DEVELOPMENT REVIEW BOARD REPORT

40-DR-2006
Nystrom Offices

Request approval of site plan and elevations for a two-story executive suite office building.

SITE PLAN W/ LIGHTING & LANDSCAPING 1/8" = 1'-0"

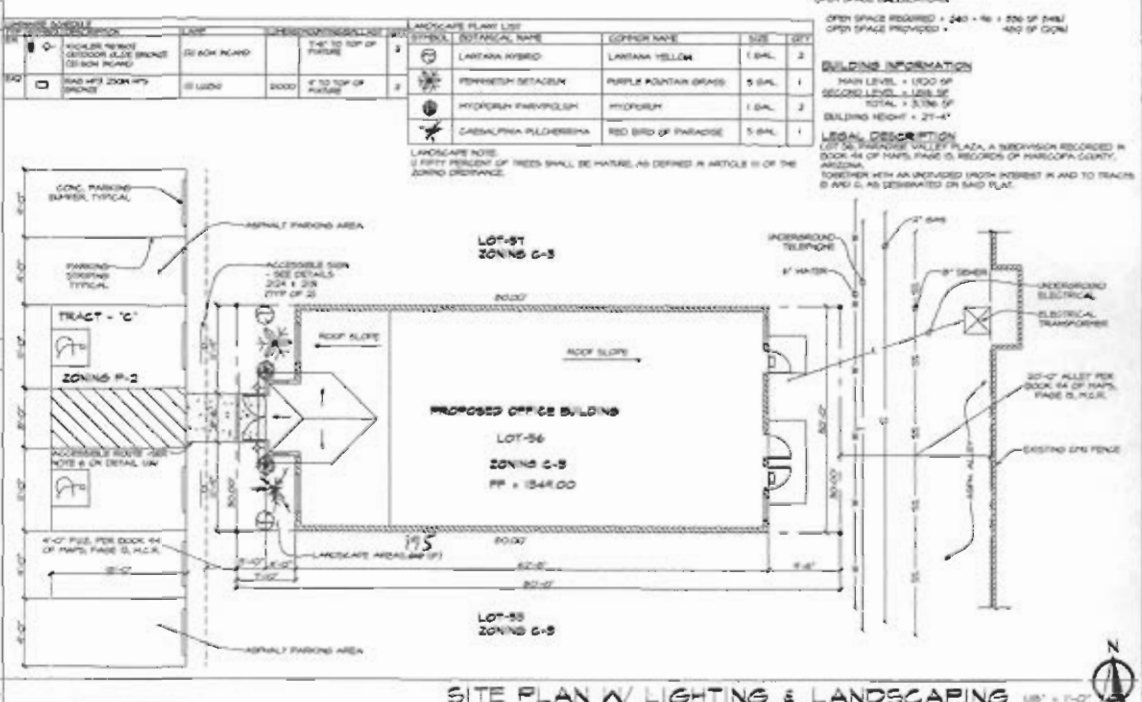
- A. *With the final plans submittal, developer shall revise open space calculations/worksheet to reflect to correct height of the building and correct open space requirement.*

8. With the final plans submittal, developer shall provide landscaping in the rear of the building consistent with the landscaping proposed in the front of the building.
